Development Services Staff Report

File Number	PL2024-319
File Name	PRELIMINARY DEVELOPMENT PLAN – 150 & Ward Apartments
Applicant	Milhaus
Property Address	3620 SW Ward Rd.
Planning Commission Date	April 24, 2025
Heard by	Planning Commission and City Council
Analyst	Adair Bright, AICP, Senior Planner

Figure 7 – Typical "Building A" (side elevation)

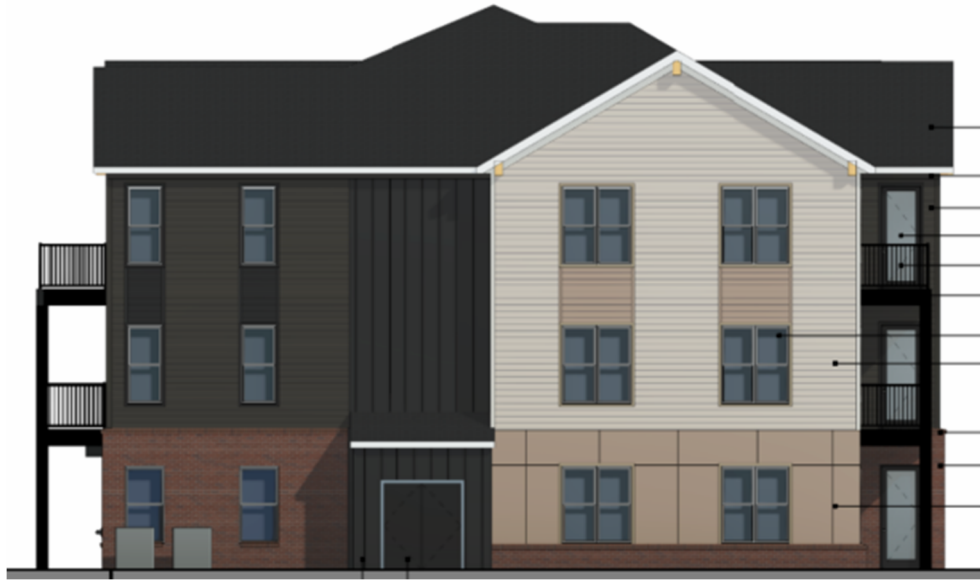
4. The applicant has requested a modification to UDO Sec. 5.510.B.4.c(6) pertaining to building design as required by the M-150 CDO. Staff has reviewed the request and supports the modification for the reasons identified below.

- **Requirement** – At least 20 percent of all walls facing a public street shall contain windows or doorways.
 - **Proposed** – Due to the orientation of the buildings and the site having a street on three out of the four sides, the side elevations of building types A, B, and C will face the street and have less than 20% windows or doorways.

- **Staff Recommendation** – Staff is supportive of the proposed modification since the intent is to ensure street-facing facades include a mix of materials and variation. The street facing facades use five different materials including the windows and doorways. On average, the street-facing facades of buildings A, B, and C will have 11%-17% containing windows or doorways.

4. A modification shall be granted to UDO Sec. 5.510.B.4.c(6) to reduce the required percent of windows or doorways on walls facing a public street from 20% to 11% for Building Type C and 17% for Building Types A and B.

Figure 8 – Site Plan showing property lines and existing right-of-way (property line shown in thick dashed line)

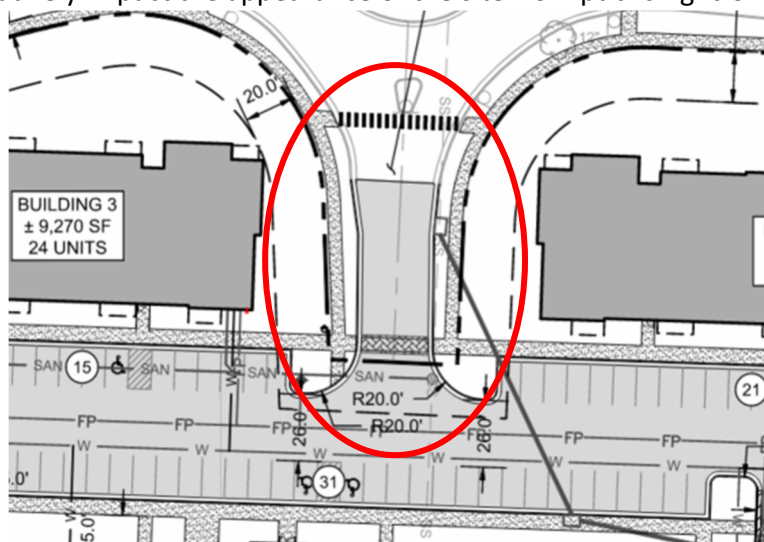
5. The applicant has requested a modification to UDO Sec. 8.620.B.1 pertaining parking lot setbacks. Staff has reviewed the request and supports the modification for the reasons identified below.
- **Requirement** – All parking lots shall be set back a minimum of 20 feet from any public right-of-way or private street edge of pavement.
 - **Proposed** – The applicant is proposing to reduce the parking lot setback adjacent to the right-of-way for the SW Arborwalk Boulevard roundabout from the required 20-ft. to 0-ft.
 - **Staff Recommendation** – Staff is supportive of the proposed modification due to how far the right-of-way cuts into the proposed site. The right-of-way extends 60-ft. south into the site from the edge of pavement of the roundabout. Approval of the modification is not anticipated to negatively impact the appearance of the site from public right-of-way.

5. A modification shall be granted to UDO Sec. 8.620.B.1 to reduce the required parking lot setback adjacent to the right-of-way for the SW Arborwalk Boulevard roundabout from 20-ft. to 0-ft.
